**CALIFORNIA REGIONAL WATER QUALITY CONTROL BOARD  
SAN DIEGO REGION**

**~~DRAFT~~TENTATIVE ADDENDUM NO. 4**

**CLEANUP AND ABATEMENT ORDER NO. R9-2004-0258**

**TDY INDUSTRIES, INC.  
(f/k/a TELEDYNE INDUSTRIES, INC.)**

**Attachment 1 - Onsite Storm Water Conveyance System**

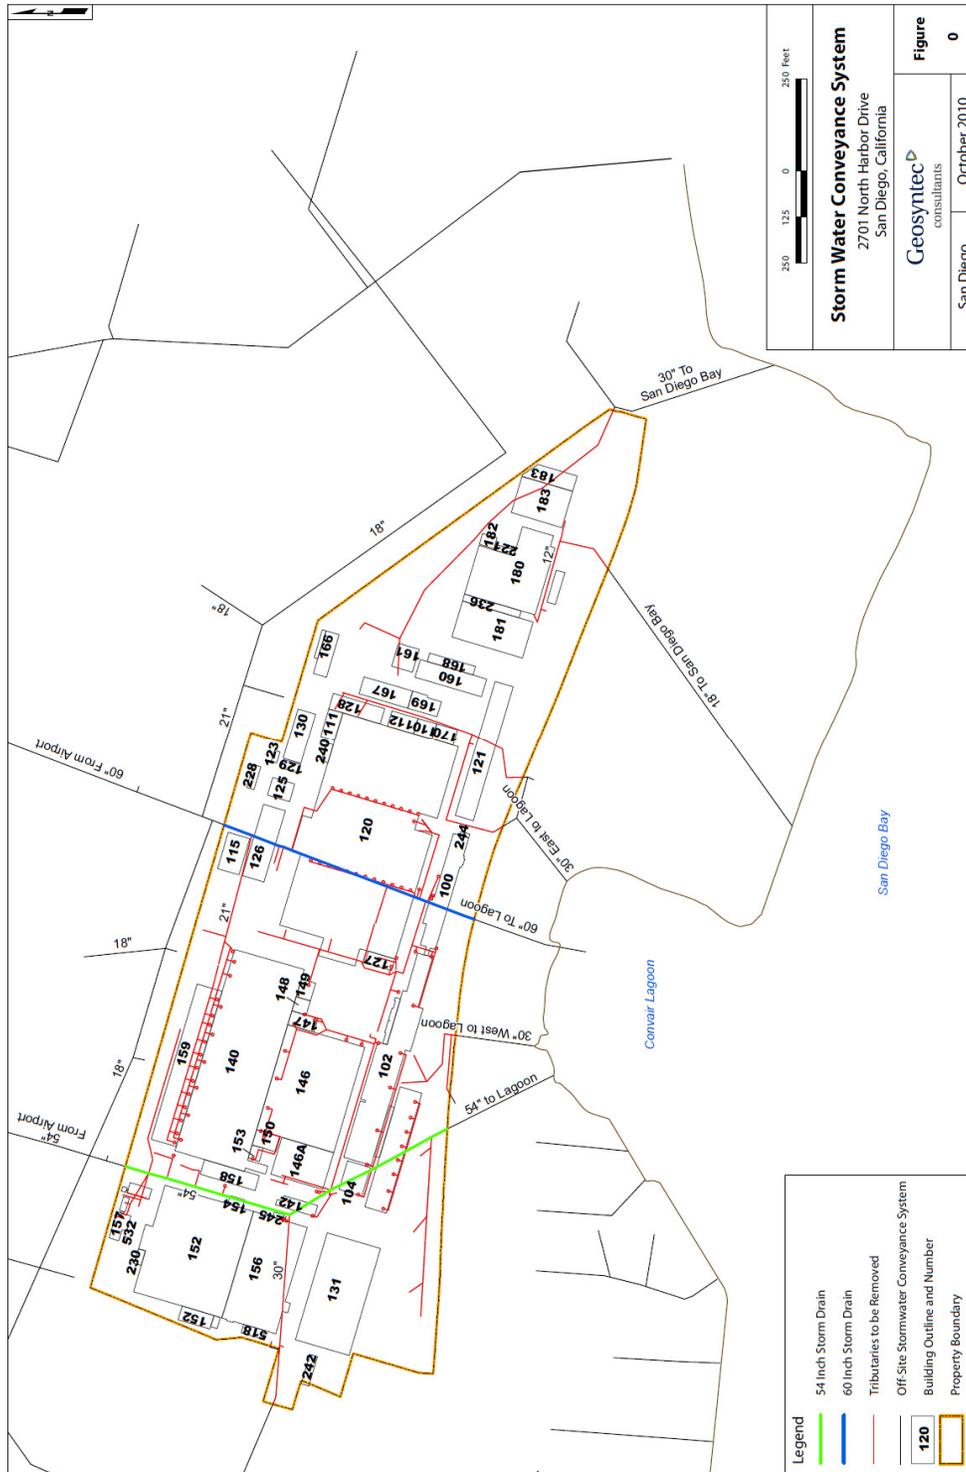
5. **ONSITE STORM WATER CONVEYANCE SYSTEM.** Site demolition will affect the onsite SWCS at the former TDY site. The SWCS is a significant pathway through which ~~contaminated~~impacted sediment is discharged into Convair Lagoon and San Diego Bay. The onsite SWCS consists of the catch basins and laterals that drain the entire 44-acre site and includes 4 storm drains that discharge storm water from the site to Convair Lagoon (shown in Attachment 1). The 4 Convair Lagoon storm drains are referred to in this Order as the 54-inch, 30-inch west, 60-inch, and 30-inch east storm drains. Additionally, 2two storm drains discharge storm water from the site to San Diego Bay. The 2two San Diego Bay storm drains are referred to in this Order as the 1518-inch and 30-inch storm drains. As part of the site demolition, all portions of the onsite SWCS that originate on the site have been capped with concrete as described below. Consequently, all storm water runoff from the site will be collected, treated, and discharged to the sanitary sewer system. Demolition activities with respect to the SWCS are described below.

- a. **60-inch Convair Lagoon Storm Drain.** This storm drain is active and only receives storm water runoff from areas upstream of the site. All laterals ~~connected~~that receive storm water runoff from the site ~~to this storm drain~~ are capped with concrete where they connect to the 60-inch storm drain and will be removed by the Port District during site demolition. This storm drain will remain in place after site demolition and will ~~be removed by the Port District during site demolition.~~ This storm drain will remain in place after site demolitioncontinue to receive storm water runoff from areas upstream of the site only until the site is redeveloped. The 60-inch storm drain is ~~owned,~~ maintained, and operated by the City of San Diego. Before entering Convair Lagoon, storm water from the 60-inch storm drain flows through an energy dissipation channel. For the purposes of this Order, the energy dissipation channel is considered to be part of the 60-inch storm drain

- b. **54-inch Convair Lagoon Storm Drain.** This storm drain is active and only receives storm water runoff from areas upstream of the site. All laterals ~~connected from the site to this storm drain~~that receive storm water runoff from the site, including the 30-inch conduit/pipe from the Airport Authority's property, are capped with concrete where they connect to the 54-inch storm drain and will be removed by the Port District during site demolition. This storm drain will remain in place after site demolition and will continue to receive storm water runoff from areas upstream of the site until the site is redeveloped. The 54-inch storm drain is ~~owned,~~ maintained, and operated by the Airport Authority.

- c. **30-inch West Convair Lagoon Storm Drain.** ~~This~~The on-site portion of this storm drain is inactive, capped with concrete at the southern property boundary, and will be removed by the Port District during site demolition. The off-site portion of this storm drain (from the concrete cap to Convair Lagoon) will remain in-place after site demolition. The 30-inch west storm drain was previously ~~owned,~~ maintained, and operated by TDY.

- d. **30-inch East Convair Lagoon Storm Drain.** ~~This~~The on-site portion of this storm drain is inactive, capped with concrete at the southern property boundary, and will be removed by the Port District during site demolition. The off-site portion of this storm drain (from the concrete cap to Convair Lagoon) will remain in-place after site demolition. The 30-inch east storm drain was previously ~~owned,~~ maintained, and operated by TDY.

- f. **30-inch San Diego Bay Storm Drain.** The on-site portion of this storm drain is inactive, capped with concrete at the southern property boundary, and will be removed by the Port District during site demolition. The off-site portion of this storm drain (from the concrete cap to San Diego Bay) will remain in-place after site demolition. The 30-inch storm drain was previously ~~owned,~~ maintained, and operated by TDY.

**Attachment 3 - Areas of Concern from Migration of Chemicals Transportation of Constituents to Convair Lagoon**

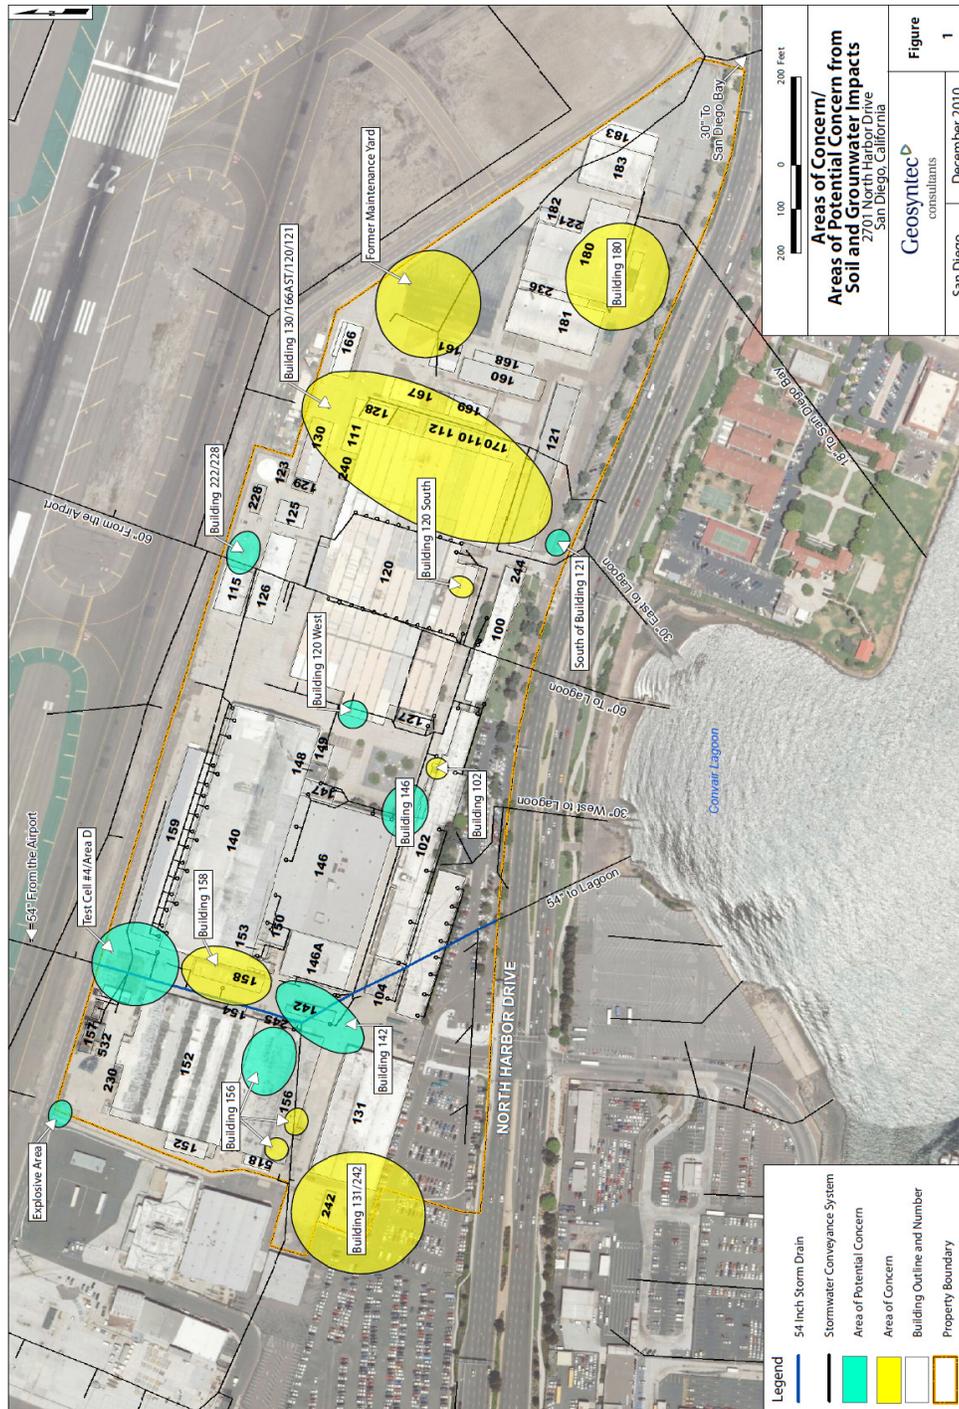
8. **CONSTITUENTS AND AREAS OF CONCERN FOR POTENTIAL TRANSPORT OF CONTAMINATED MEDIA WASTES TO CONVAIR LAGOON.** ~~The table below Table 2~~ identifies the areas of concern ~~due to~~ for the ~~potential~~ transport of ~~contaminated media wastes~~ to Convair Lagoon, and identifies whether or not interim remedial actions have been conducted. The AOCs include:

- a. the Convair Lagoon shoreline where constituents concentrations above California Toxics Rule (CTR) criteria were detected in groundwater in monitoring wells installed along the Convair Lagoon shoreline,
- b. the Convair Lagoon storm drains (60-inch, 54-inch, 30-inch west, and 30-inch east) and San Diego Bay storm drains (18-inch and 30-inch) which contain PCB-contaminated sediment from the site that can be transported to the lagoon and bay, and
- c. the 60-inch and 54-inch Convair Lagoon storm drains where VOC wastes were detected below CTR criteria in groundwater seeping into the storm drains,

These areas of concern are ~~described~~ further discussed in Finding 10 and are shown in Attachment 3.<sup>4</sup>

**Attachment 7-- PCB Impacts in Soil**

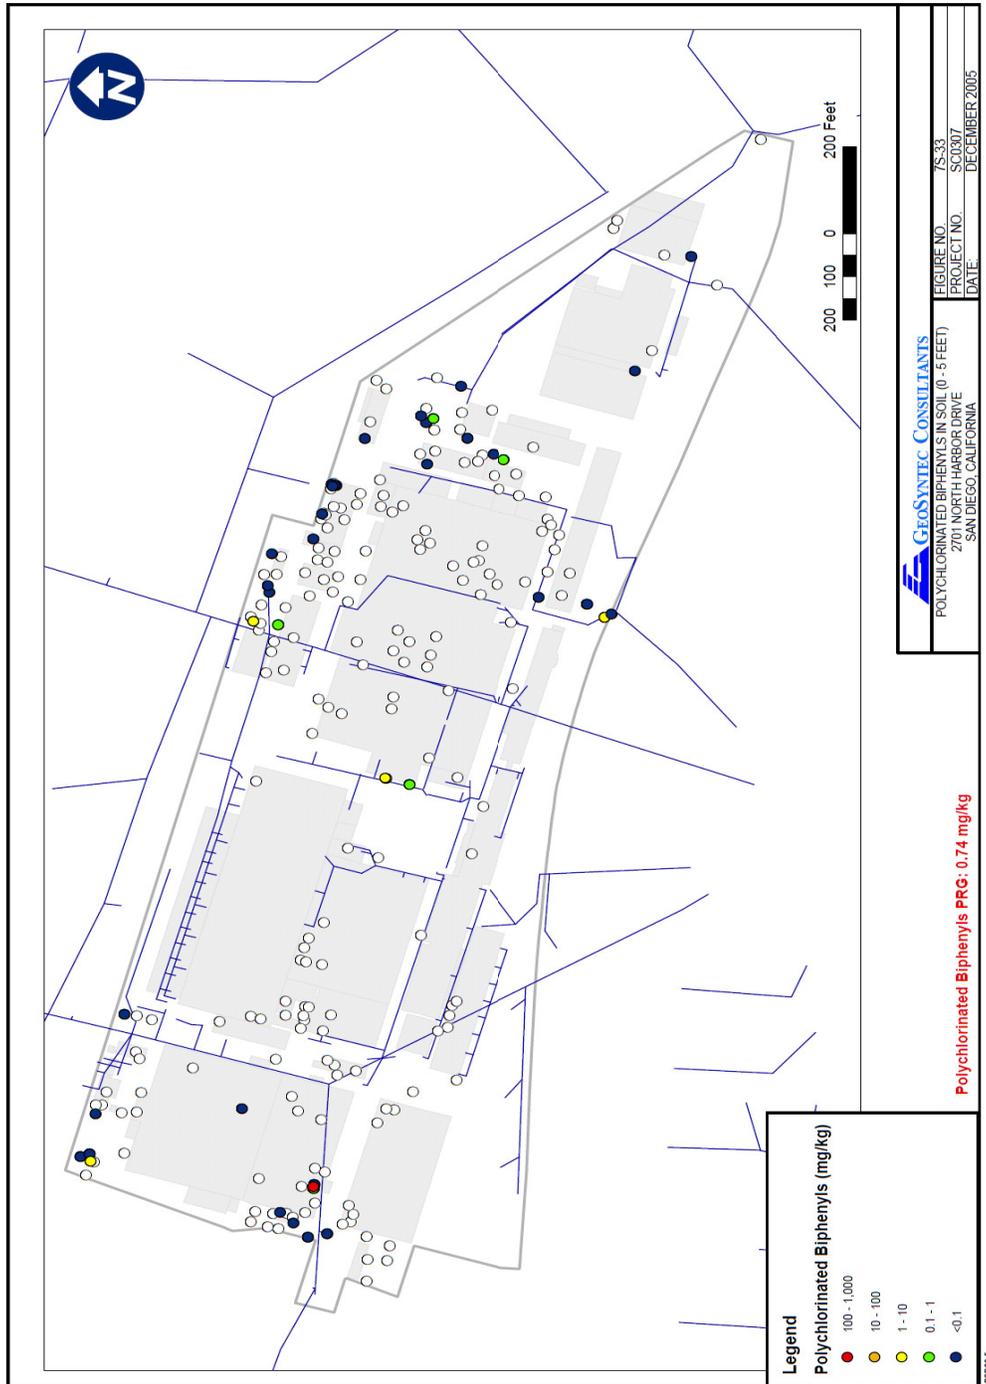
- c. ~~Soil.~~ PCB impacts in contaminated soil are is not widespread as shown in Attachment 7 at the site. Site characterization data shows relatively few areas with localized PCB impacts. These areas have been largely addressed by interim removal actions as described in Finding 16.d.; however, remaining impacts impacted areas include areas in the Building 120 South AOC, Building 180 AOC, and an area in the vicinity of the 30-inch east storm drain excavation. These remaining PCB-impacted areas will be remediated as discussed in Finding 17.
